UNITED STATES PATENT AND TRADEMARK OFFICE

APPLICATION NO.	FILING DATE	FIRST NAMED INVENTOR	ATTORNEY DOCKET NO.	CONFIRMATION NO.
10/613,824	07/03/2003	Mustafa Eroz	PD-203009	6911

Office Action Summary	Application No. 10/613,824	Applicant(s) EROZ ET AL.	
	Examiner Mujtaba K. Chaudry	Art Unit 2133

DETAILED ACTION

Figure 15

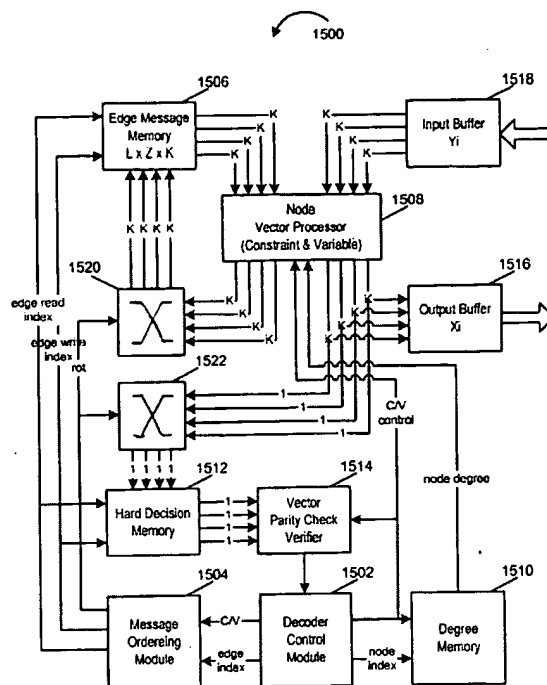
As per claim 2, Richardson teaches (Figure 15) an edge memory which stores the edge values as stated in the present application.

As per claim 3, Richardson teaches (Figure 15) the number of edges attached to a node, i.e., a variable node or constraint node, is referred to as the degree of the node. A regular graph or code is one for which all-variable nodes have the same degree, j say, and all constraint nodes have the same degree, k say. In this case we say that the code is a (j,k) regular code. In contrast to a "regular" code, an irregular code has constraint nodes and/or variable nodes of differing degrees. For example, some variable nodes may be of degree 4, others of degree 3 and still others of degree 2.

graph connect variable nodes to constraint nodes. A variable node and a constraint node are said to be neighbors if they are connected by an edge in the graph. For simplicity, we generally assume that a pair of nodes is connected by at most one edge. To each variable node is associated one bit of the codeword. A bit sequence associated one-to-one with the variable node sequence is a codeword of the code if and only if, for each constraint node, the bits neighboring the constraint (via their association with variable nodes) sum to zero modulo two, i.e., they comprise an even number of ones. The decoders and decoding algorithms used to decode LDPC codewords operate by exchanging messages within the graph along the edges and updating these messages by performing computations at the nodes based on the incoming messages. Such algorithms will be generally referred to as message passing algorithms. Each variable node in the graph is initially provided with a soft bit, termed a received value, that indicates an estimate of the associated bit's value as determined by observations from, e.g., the communications channel. Richardson teaches (Figure 15) an edge memory which stores the edge values as stated in the present application.

As per claim 13, Richardson teaches (Figure 15) the number of edges attached to a node, i.e., a variable node or constraint node, is referred to as the degree of the node. A regular graph or code is one for which all-variable nodes have the same degree, j say, and all constraint nodes have the same degree, k say. In this case we say that the code is a (j,k) regular code. In contrast to a "regular" code, an irregular code has constraint nodes and/or variable nodes of differing degrees. For example, some variable nodes may be of degree 4, others of degree 3 and still others of degree 2.
